Docket Item # 7 & 8  
BAR CASE #2011-0367 & 0368

BAR Meeting  
January 18, 2012

**ISSUE:** Partial Demolition/Encapsulation, Alterations and Waiver of Rooftop HVAC Screening

**LOCATION:** 204 and 206 South Union Street

**Figure 7. Existing conditions and areas of proposed demolition.**

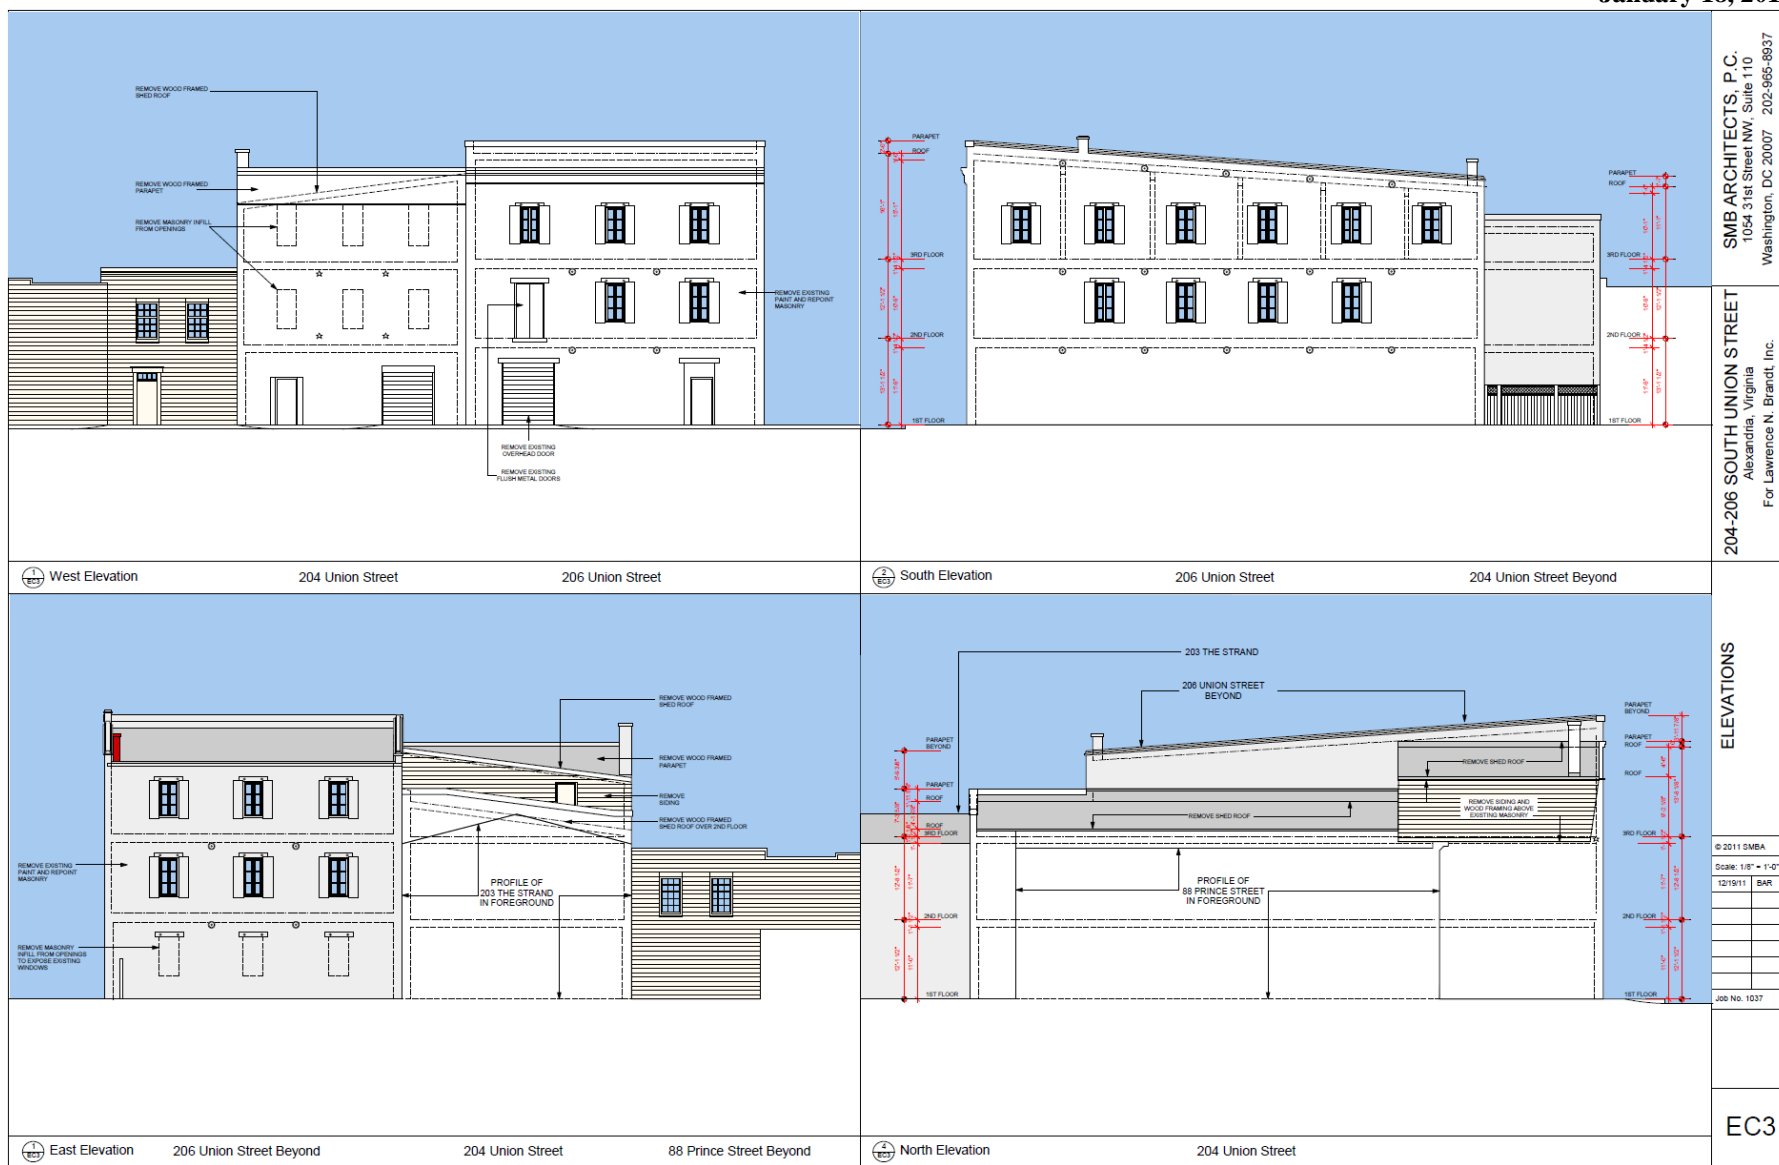
In the opinion of Staff, none of the criteria for demolition and encapsulation are met and the Permit to Demolish should be granted. The scope of the proposed demolition is minimal is part of a larger restoration that will return the two warehouses closer to their original appearance. The addition of windows and doors, particularly at the first level, is a common and typical type of alteration that allows buildings throughout the historic districts to be adaptively reused and the existing first floor brick wall is not of such unusual or uncommon design, texture and or material that it could not be easily reproduced. The demolition of the existing roof at 204 South Union Street is acceptable as that roof is not original to the building and has been altered many times. Additionally, that shed roof is not visible and its removal and replacement will not compromise the integrity of this building.

Figure 10 Proposed floorplans, rooftop.

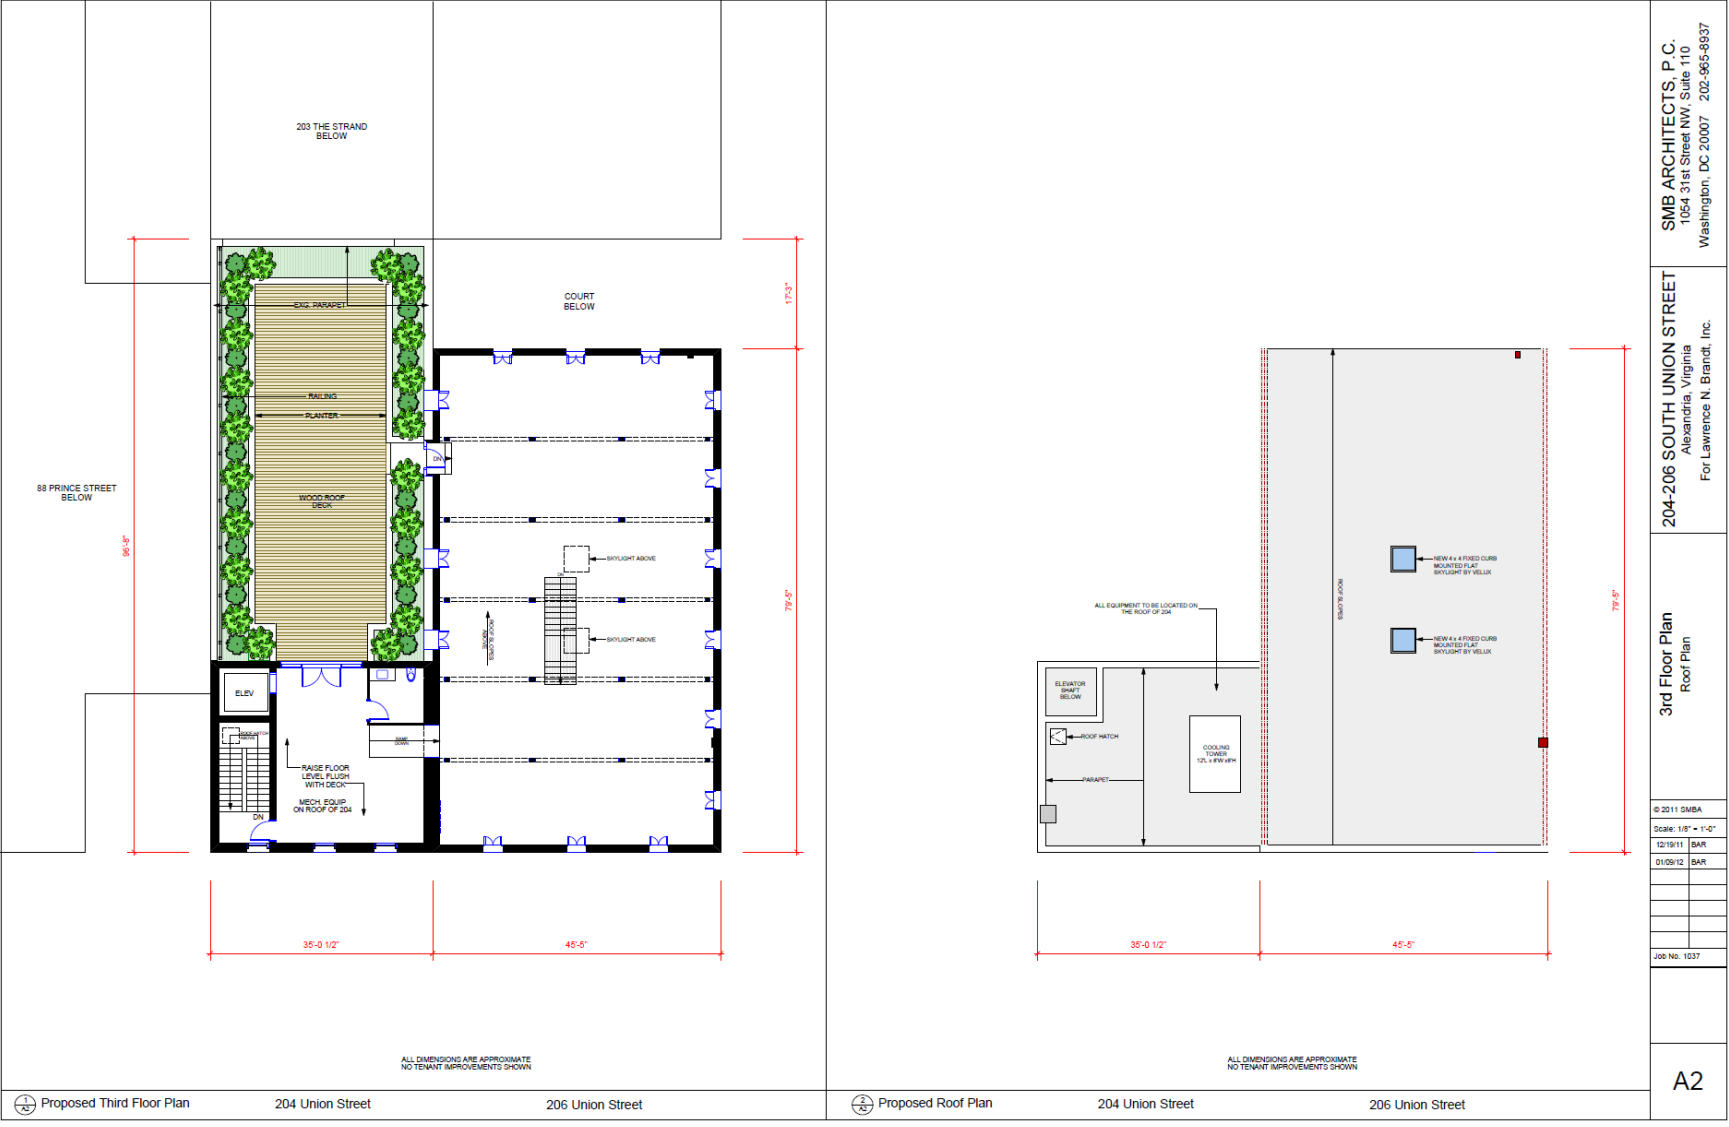
Staff has no objection to the request for a waiver of the rooftop HVAC screening requirement at the front of 204 South Union Street and believes that the rebuilt parapet will largely screen the proposed cooling tower from most vantages.

**Figure 11: Proposed metal window specifications.**

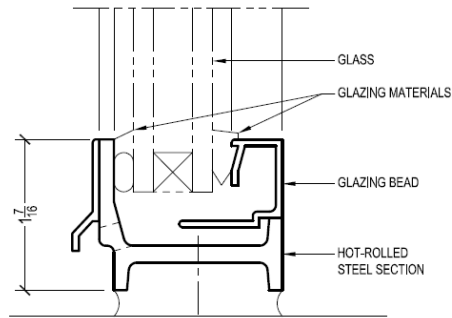
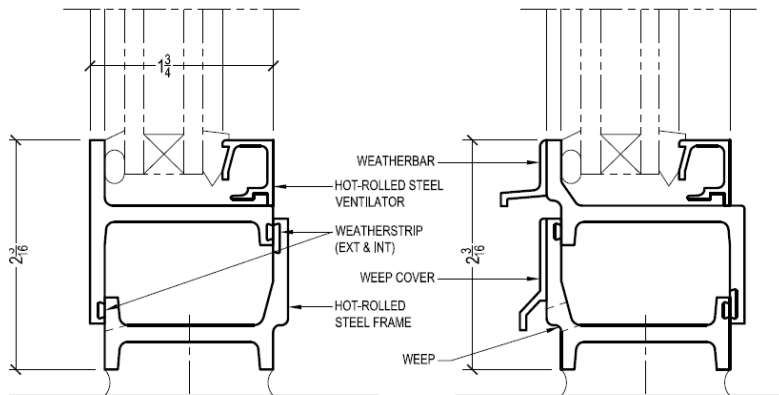
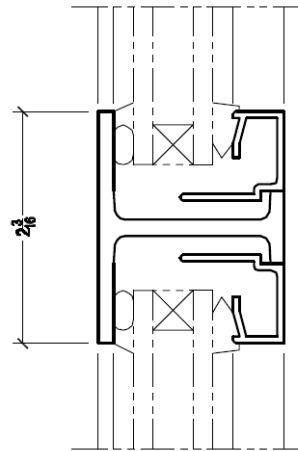
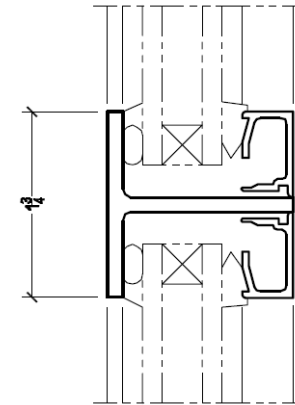
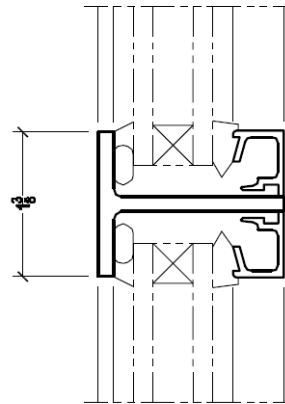
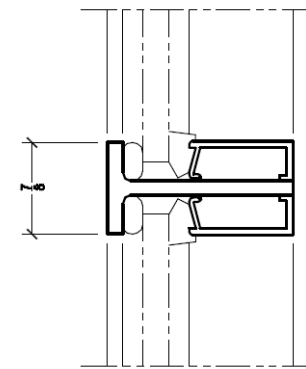
The use of metal windows and doors for the storefront system is appropriate for these former industrial warehouses. Staff suggested that the applicant use the openings at the first floor of the mid-19<sup>th</sup> century warehouse at 201 King Street for a design reference (see Figure #12) for the new ground floor openings at 206 South Union. For the upper floors, the applicant initially proposed double-glazed wood windows at 204 South Union Street. However, Staff advised that such windows are not in keeping with the Board's adopted Window Policy which requires single-glazed wood windows for the front elevations (only) of 18<sup>th</sup>- and 19<sup>th</sup>-century buildings. The applicant has agreed to select a window in keeping with the Window Policy. Staff notes that single-glazed windows with a factory, interior energy panel are an energy efficient option.

1. That all new or replacement windows be in conformance with the Board's adopted Window Policy; and
2. That the historic iron fenders and door shields be retained *in situ* where possible or reused on the site.
